Service Bulletin

SUBJECT: Service Update for Inventory and Customer Vehicles
#5 Bar Cold Welds
Expires with Base Warranty

MODELS: 2015 Chevrolet Cruze

Subject: 15079 – Service Update Bulletin
#5 Bar Cold Welds

4109727

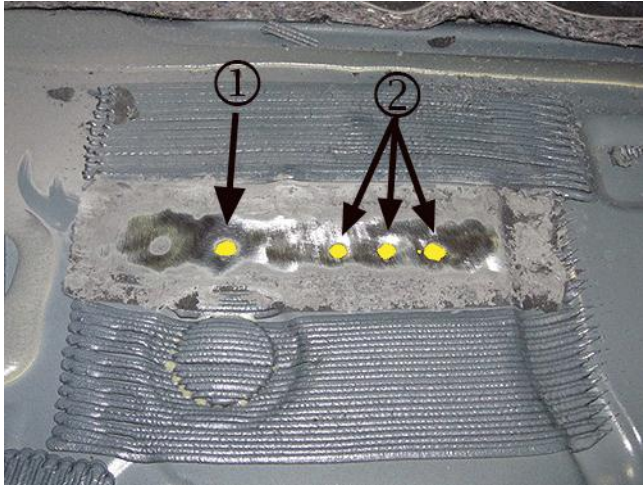
2. Remove the load floor to identify the left side, forward row of spot welds.

Note: The floor repair area is easier to access from the rear passenger compartment.

4109728

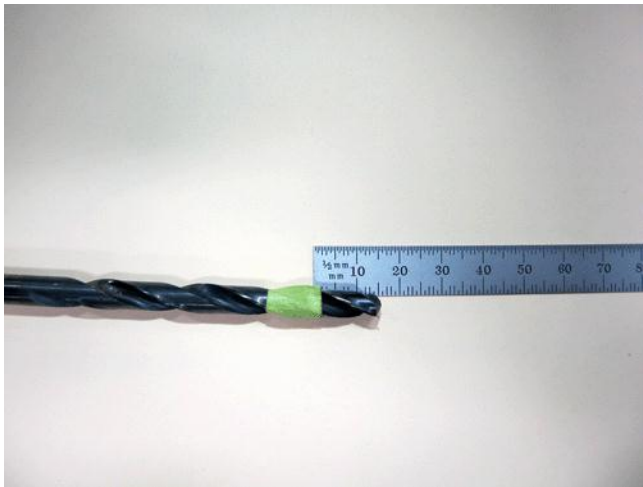
5. Identify the possible four affected welds; the first (1) located just forward of the body plug and the next three (2) inline inboard.

4109732

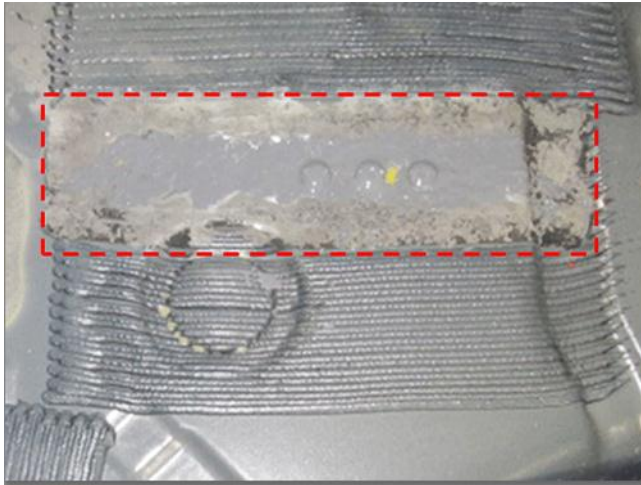
12. Install the rivet using a rivet gun.

13. Repeat this rivet installation in the second and third locations.
